ADDENDUM NO. 2

CHICOPEE-HOLYOKE-NORTHAMPTON-SPRINGFIELD-WEST SPRINGFIELD
Bridge Preservation of 26 Bridges along I-91

Questions and Responses

Addendum No.2, December 12, 2025

Chart 1: Cracked Weld and Base Metal on Steel End Diaphragms

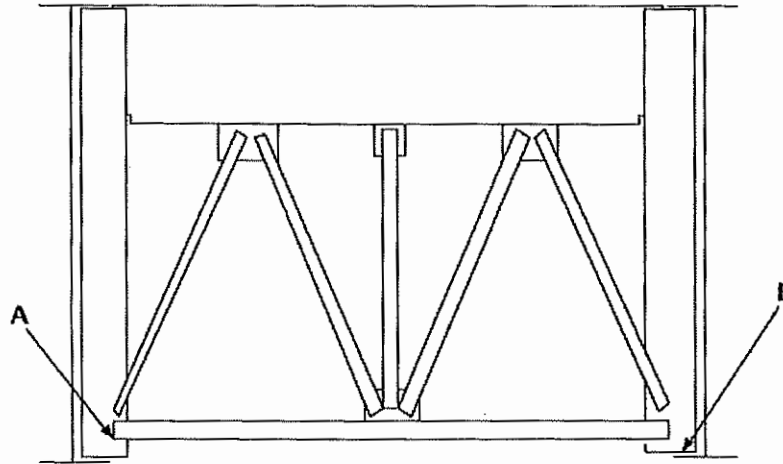
There are specific welded repairs to the end diaphragms shown on pages A00808-16, bridge structure 10A and on A00808-43, bridge structure 10B (both pages attached for reference). Does the Department intend to perform any 961 activities to the welded end diaphragms?

If yes, what length of 961 activities would be required? For example, 6” extending in all directions of the welded repair or the full diaphragm would be cleaned (full removal) and painted? Is payment measured by the SF?

Only areas requiring steel repairs will be painted as part of this project. See Document A00804 for anticipated locations to be cleaned and painted as part of this project.

Photo 5: At Pier 2, the drainpipe is disconnected, and is leaking onto the roadway below.

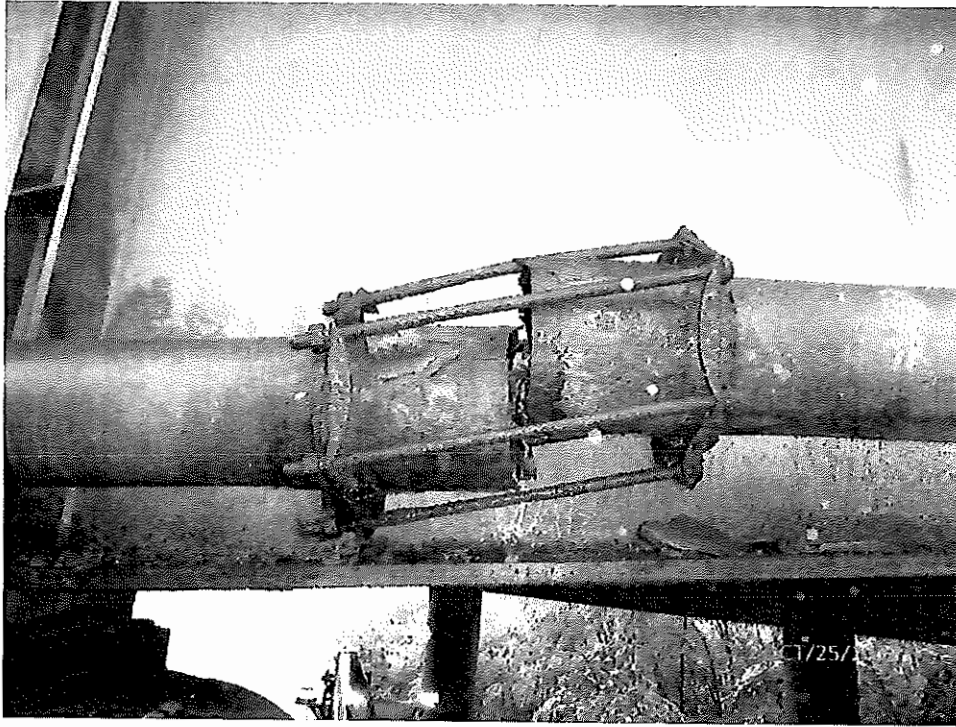
On page A00808-46, photo # 5 (page attached for reference) identifies a broken steel drain pipe. Would there be any 961 activities (painting) required to be performed at these locations?

If yes, is this measured and paid by the SF unit price?

Repairs to the broken steel drainpipe identified in the attached bridge inspection report is not covered in this contract. See Document A00804 for anticipated locations to be cleaned and painted as part of this project.
